Access Compliance Report Public Rights-of-Way (Curb Ramps)

Main Street: BOND_AVE Cross Street: HEWES_ST Location: SE

ADA ID: RPAT211027141207 Ramp Type: Type 4 - Parallel Initial Pass/Fail: Fail Overall Compliance: No Severity Score: 15

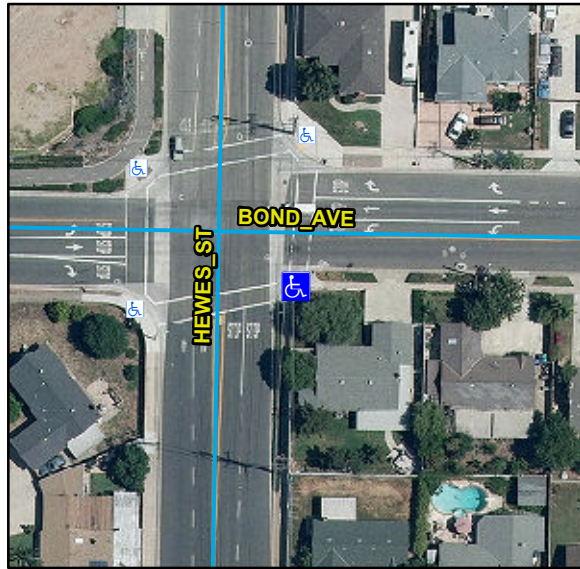
Compliance	Description	Data	Compliance	Description	Data
N/A	Ramp Length LT (in)	66	N/A	Ramp Length RT (in)	70
Yes	Ramp Width LT (in)	94	Yes	Ramp Width RT (in)	89
No	Ramp Run Slope LT (%)	8.6	Yes	Ramp Run Slope RT (%)	6.2
Yes	Ramp Cross Slope LT (%)	1.5	Yes	Ramp Cross Slope RT (%)	0.2
N/A	Landing Present	N/A	N/A	DWS Provided	N/A
N/A	Landing Length (in)	N/A	N/A	DWS Contrast	N/A
N/A	Landing Width (in)	N/A	N/A	DWS Length (in)	N/A
N/A	Landing Run Slope (%)	N/A	N/A	DWS Full Width	N/A
N/A	Landing Cross Slope (%)	N/A		DWS Offset Type	N/A
N/A	Landing Movement Obstructed?	N/A	N/A	DWS Offset Left (in)	N/A
	Landing Movement Type	N/A	N/A	DWS Offset Right (in)	N/A
N/A	Landing Shared	N/A			
N/A	Clear Space	Yes			
N/A	Clear Space To Crosswalk (in)	N/A			
N/A	Marked Crosswalk 1	No	N/A	Marked Crosswalk 2	No
	Crossing 1 Direction	N		Crossing 2 Direction	W
	Marked Crosswalk 1 Width (in)	N/A		Marked Crosswalk 2 Width (in)	N/A

Remove & Replace Curb Ramp With Two New Directional Ramps or Equivalent.

R304.3.2, STD 1115
